Addendum 2

RFQMA24 – 5030

Glenforest Secondary School City of Mississauga

Pool Demolition

Graphic Scale		Sheet no.
AS SHOWN		E7
Drawn RS	Checked SS	
CAD File -	Scale AS NOTED	Revision No.
Date DECEMBER 2022	Project No. 23-124

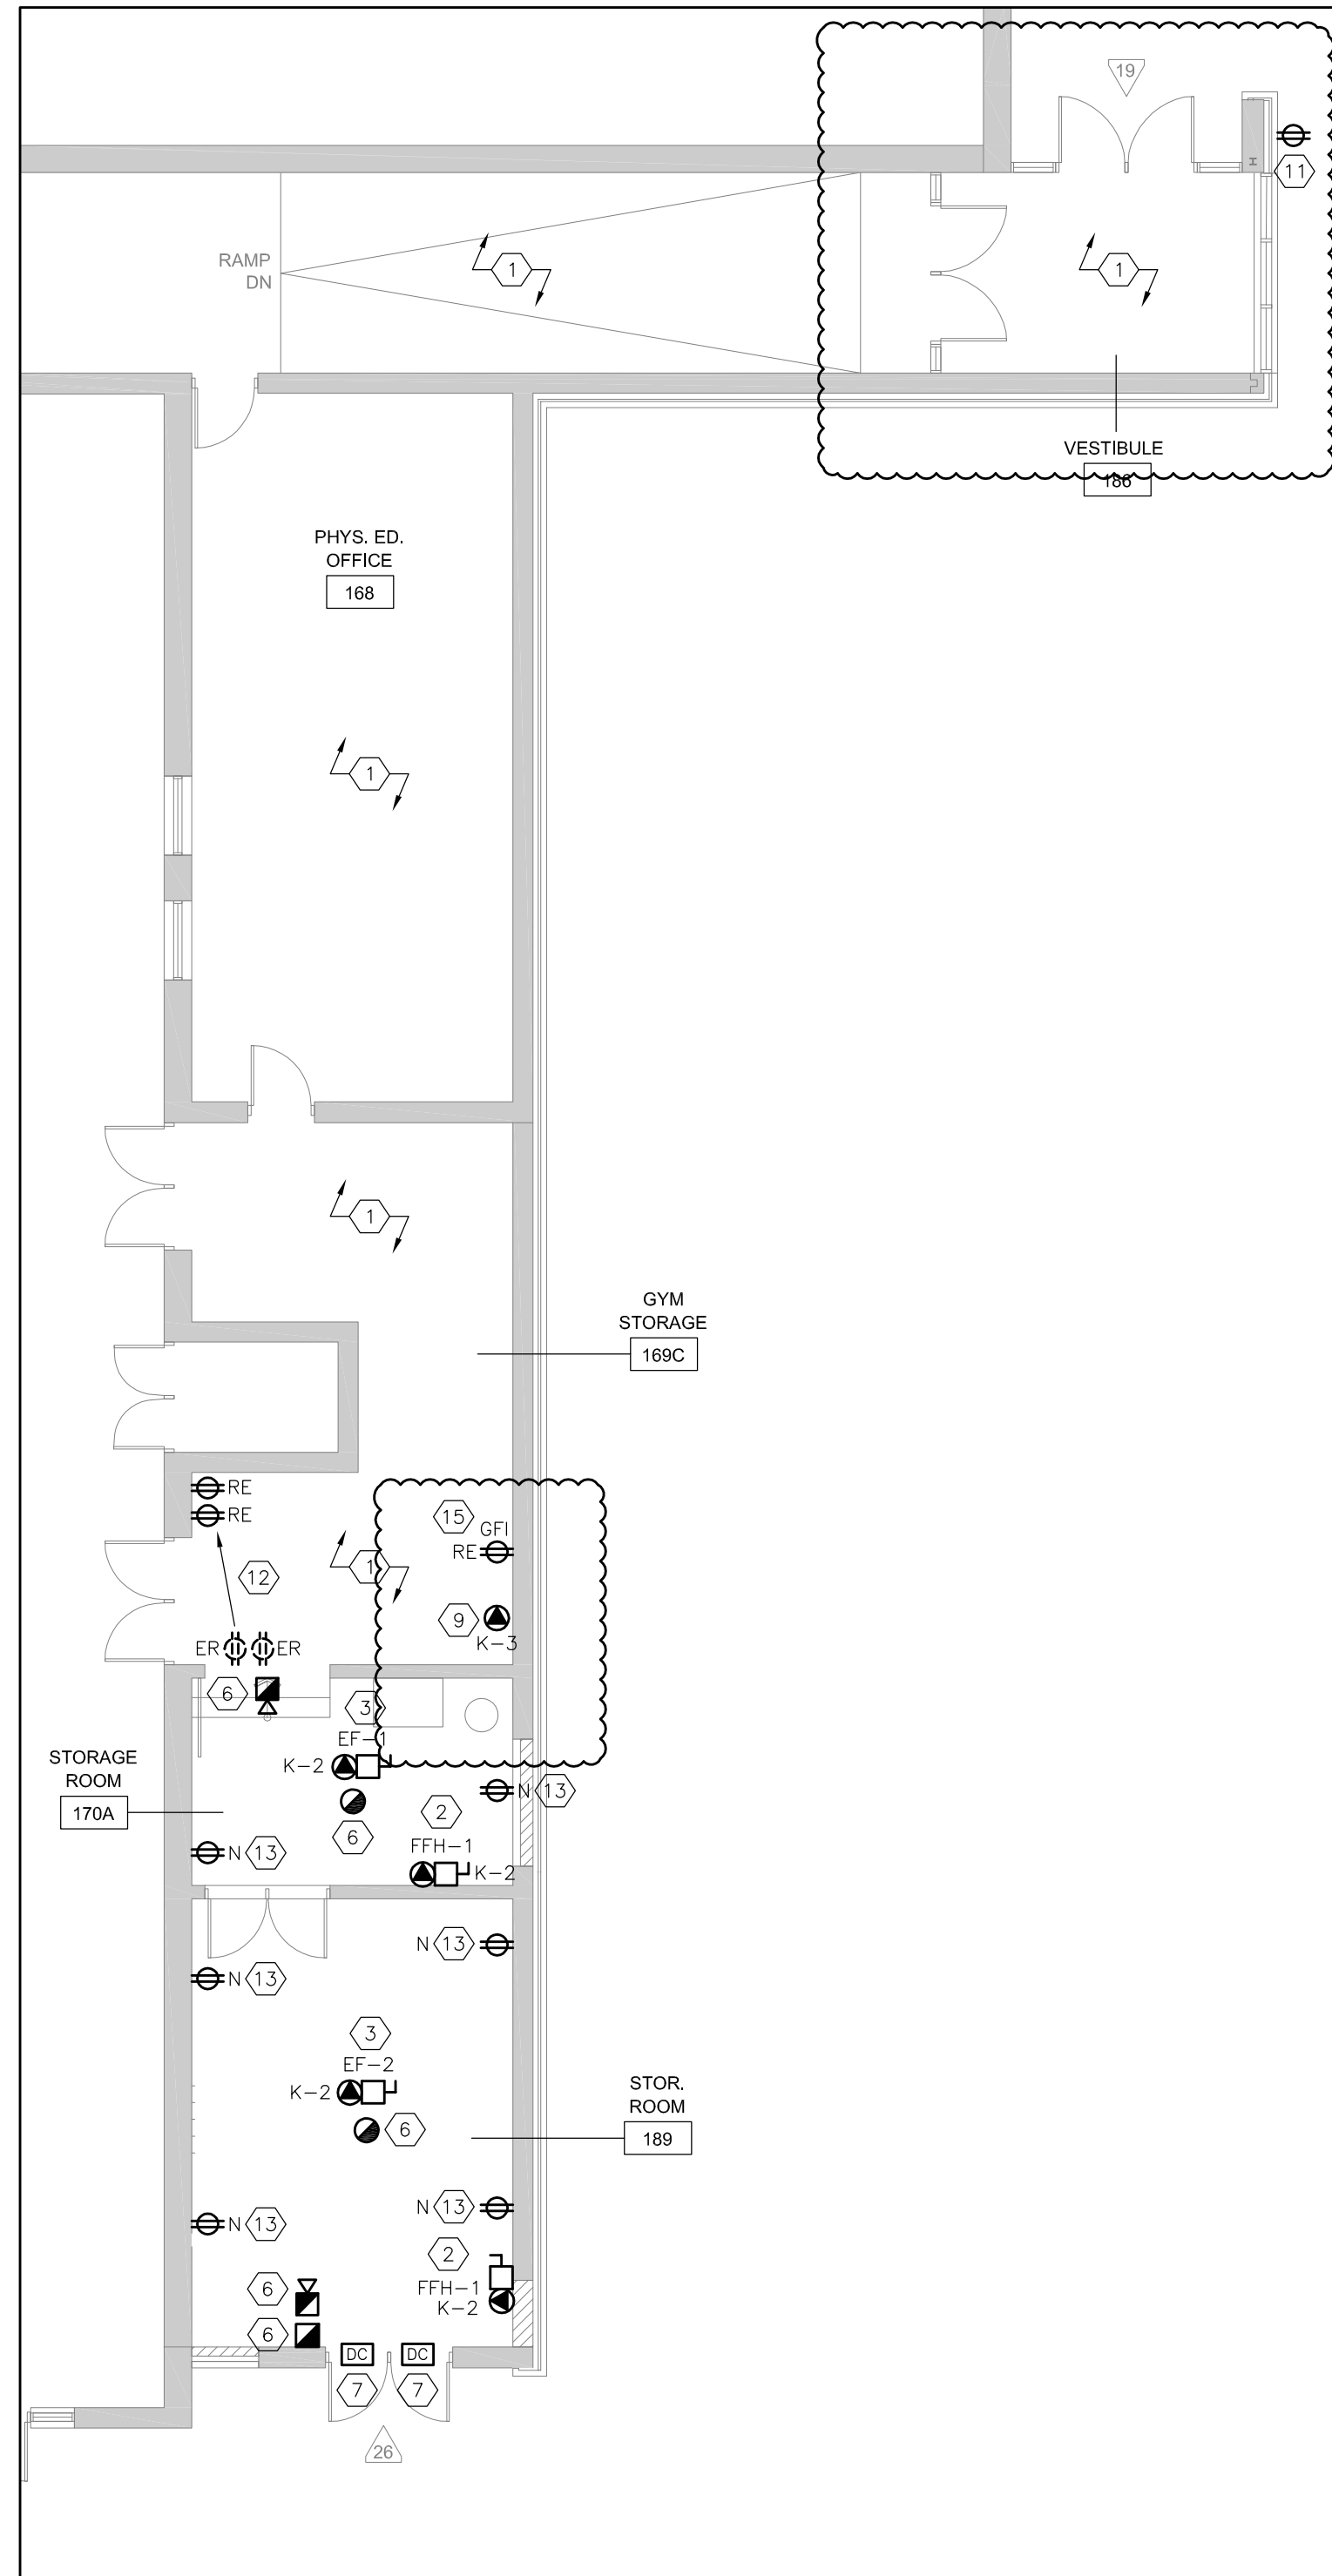
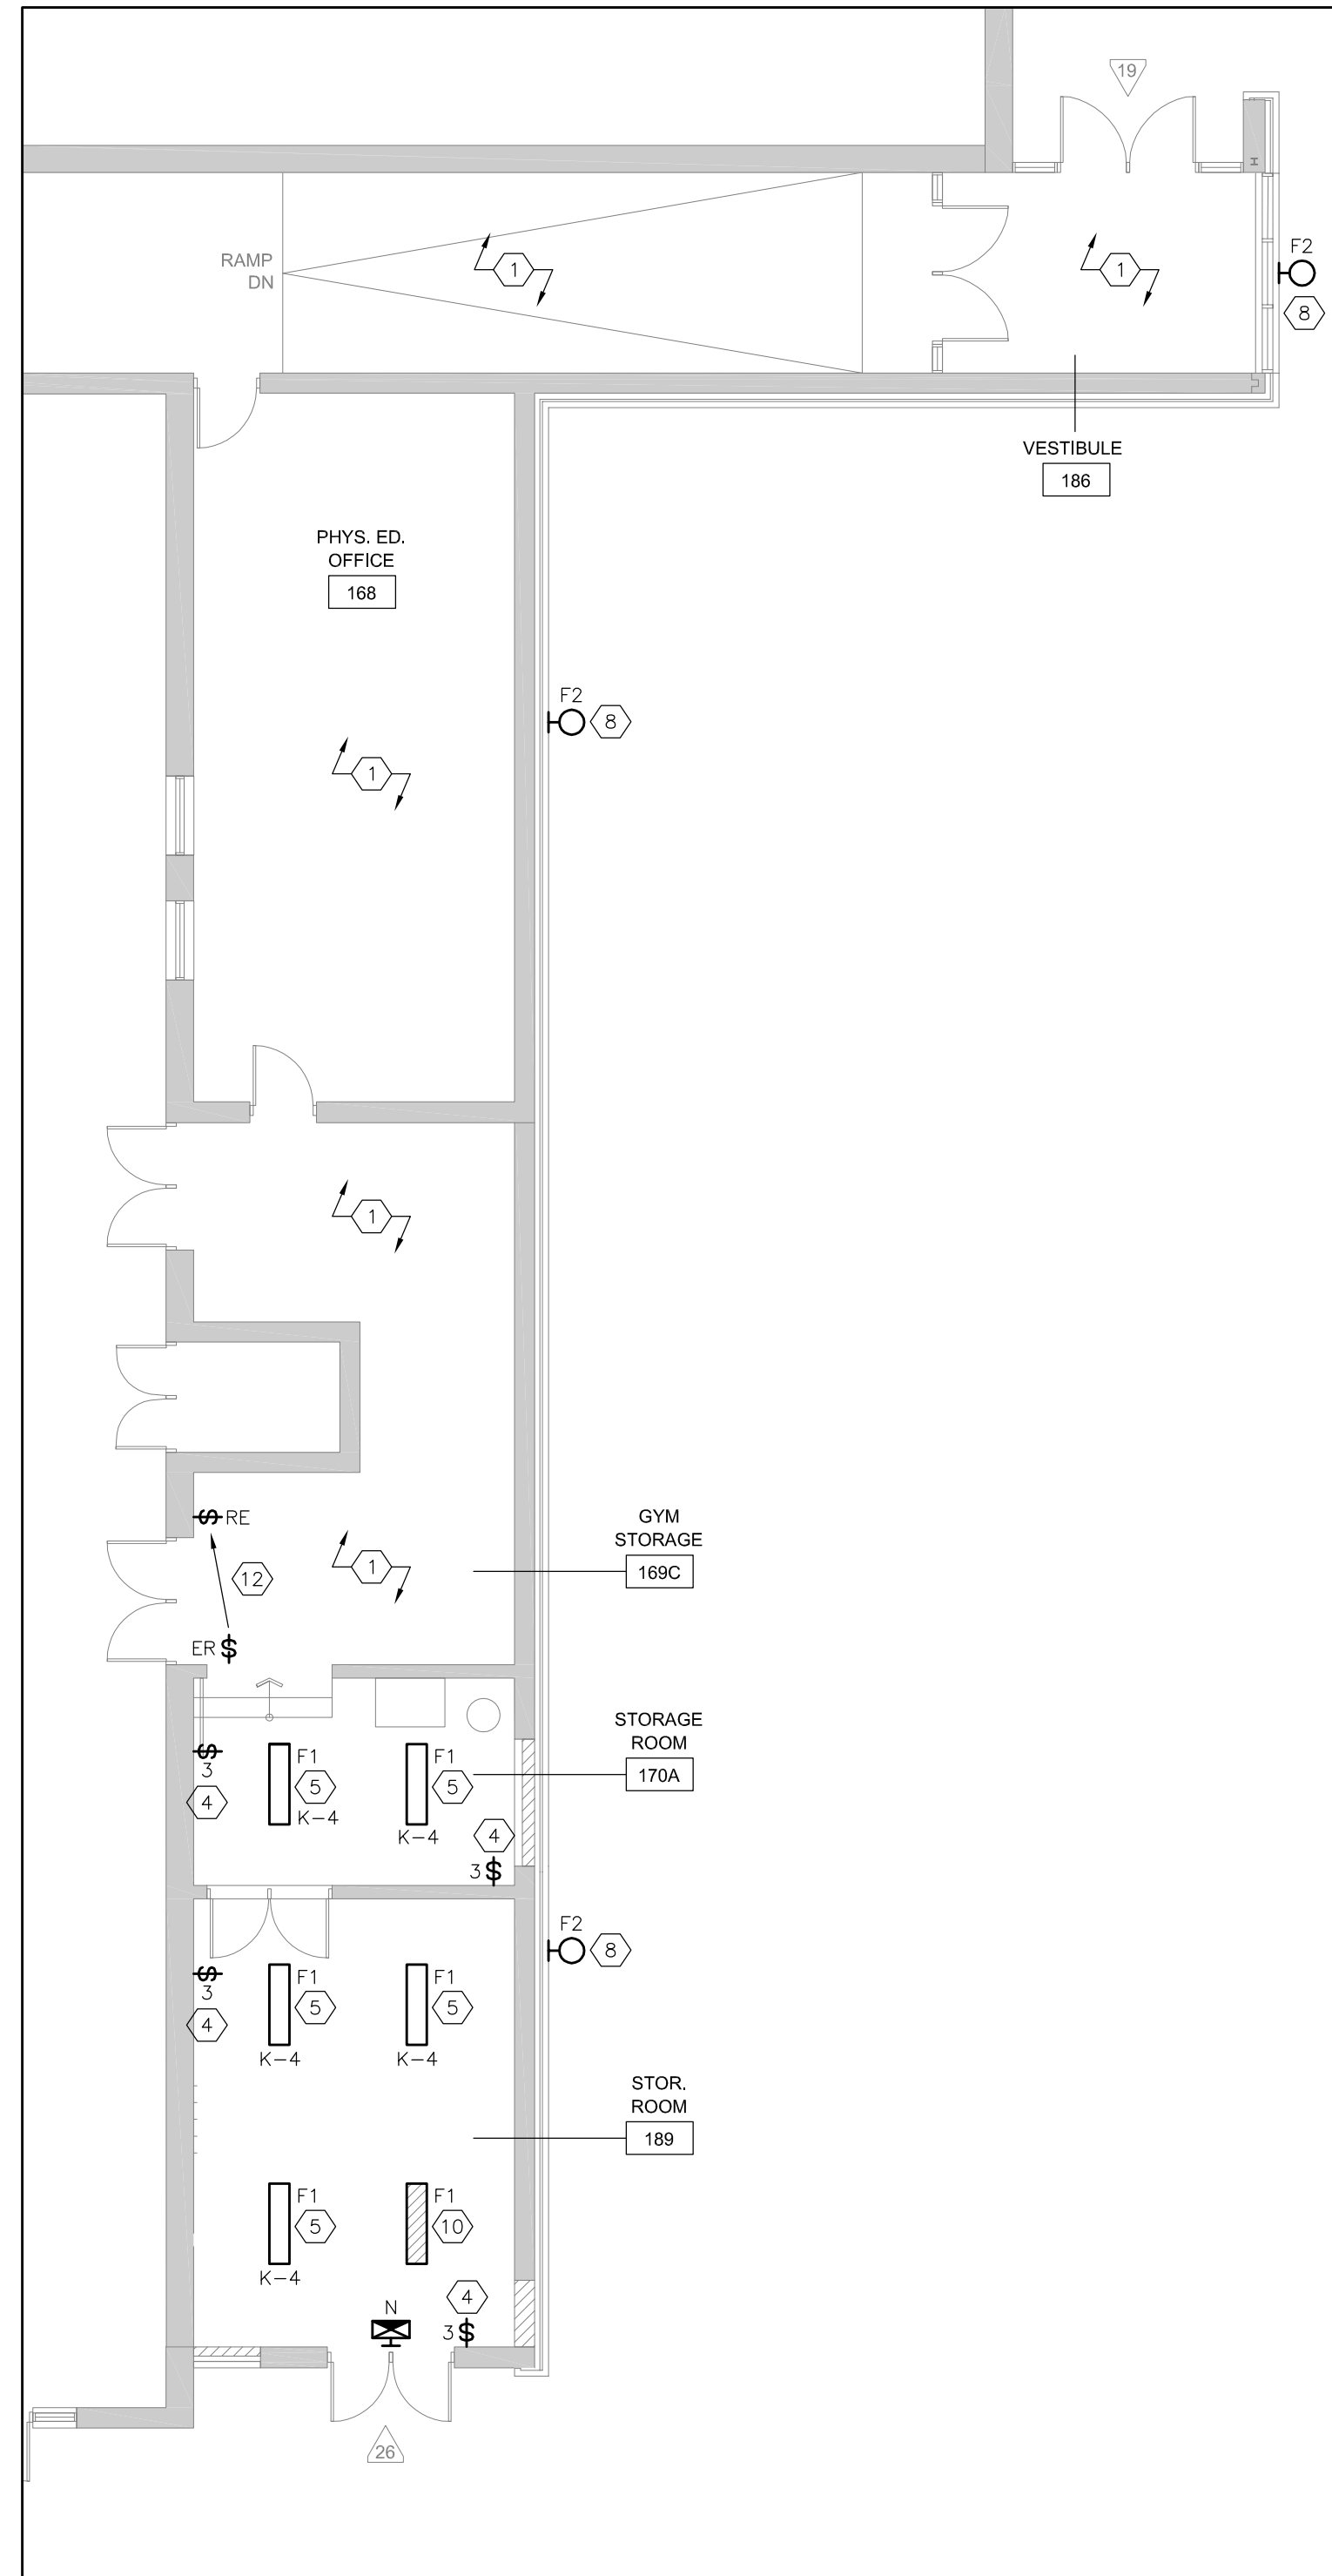
1. See attached re-issued Drawing with Clouded Revisions.

- 15 RELOCATED EXISTING GFI PLUG (FORMALLY IN THE POOL - SEE DRAWING E5) AND ALL ASSOCIATED CONDUIT/WIRING TO THE GYM STORAGE, RE-FEED RECEPTACLES IN THE GYM TO MAINTAIN CONTINUITY OF POWER IN THE GYM AFTER COMPLETION OF DEMOLITION OF THE POOL.
